verizon
BLOOMINGTON MSC EXPANSION
10801 BUSH LAKE ROAD
BLOOMINGTON, MN.

NETWORK COMPLIANCE SUBMITTALS	DATE
ISSUED FOR PRELIMINARY REVIEW	04/24/2020

1 OVERALL FLOOR PLAN
SCALE: 1/16" = 1'-0"

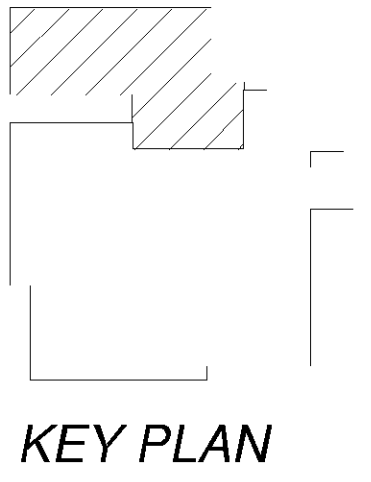
The purpose/use of the training rooms has a significant impact on the overall parking requirement. If the training room is used for on-site employees, we would calculate the space as office. If the rooms are used for trainings where the participants are not located at site, we would calculate the space as assembly, which has a higher parking requirement.

As office, the preliminary parking requirement is 120 stalls. As assembly, the parking requirement increases to 152 stalls. Either way, additional parking must be addressed with the plan submittal through additional parking provided on site and/or proof of parking.

SITE PLAN

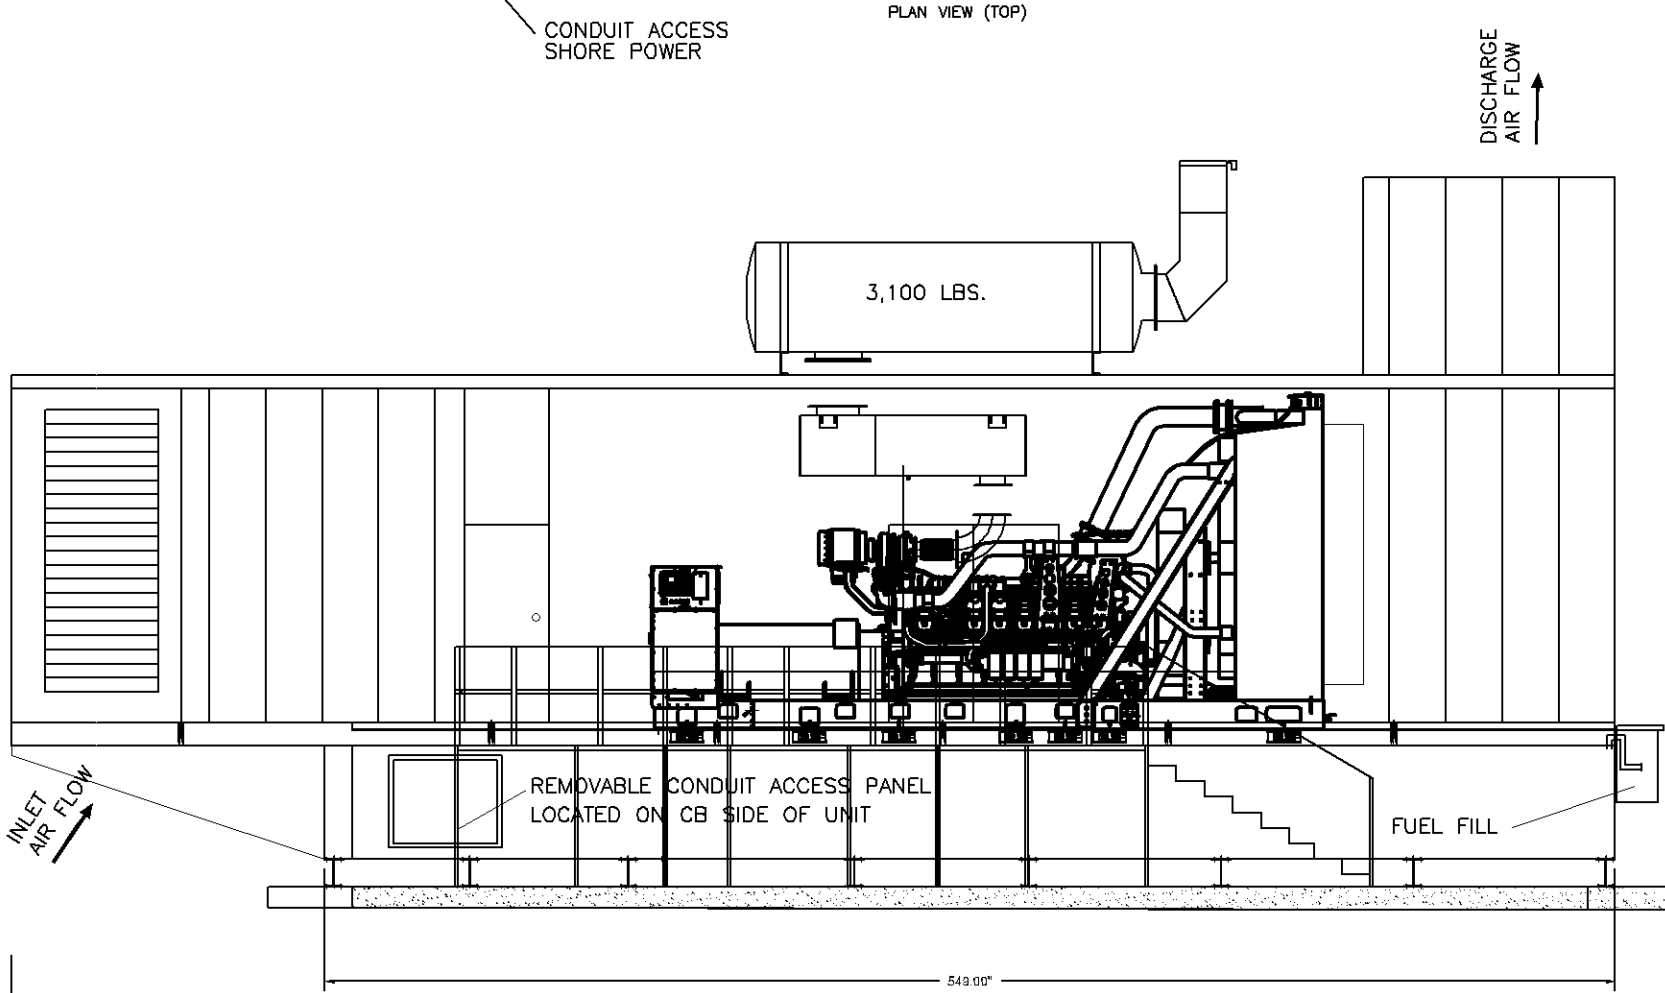
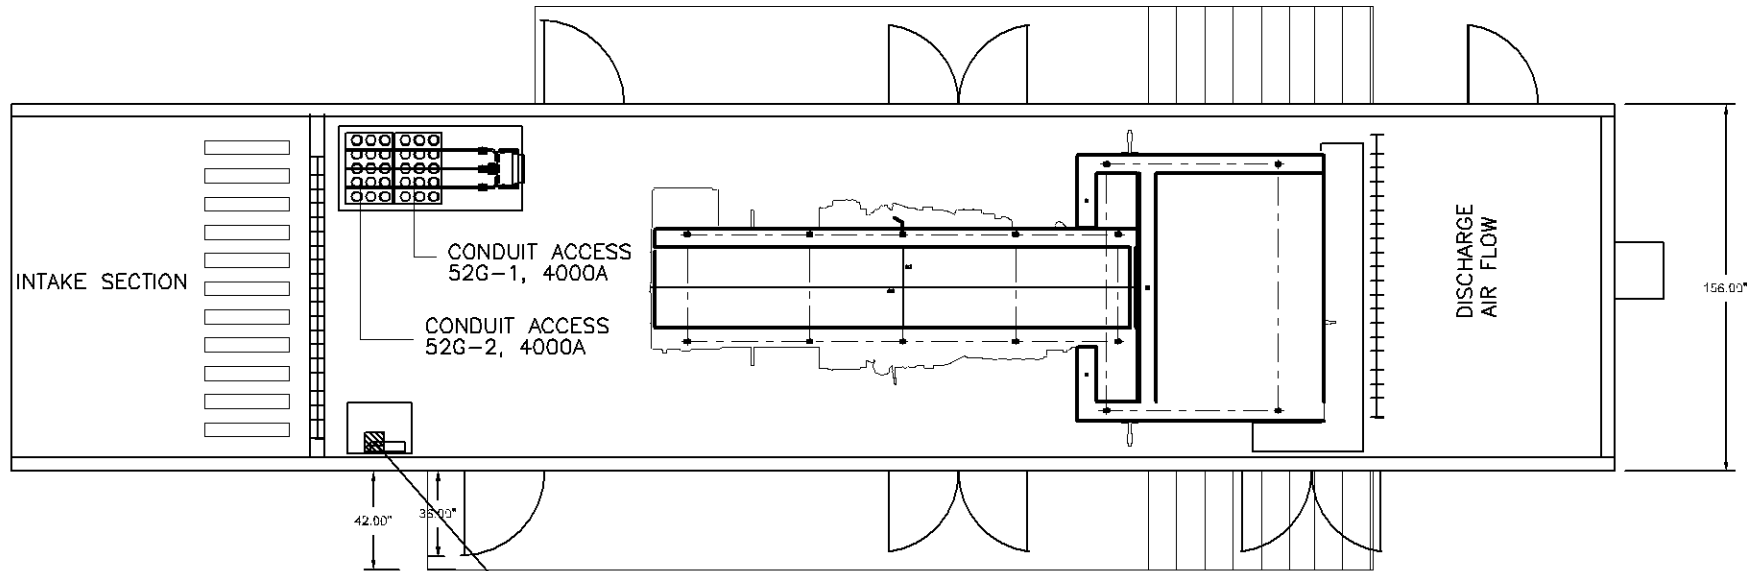
Fire alarm, annunciator panels and Knox box location(s) to be determined by the Fire Prevention Division.
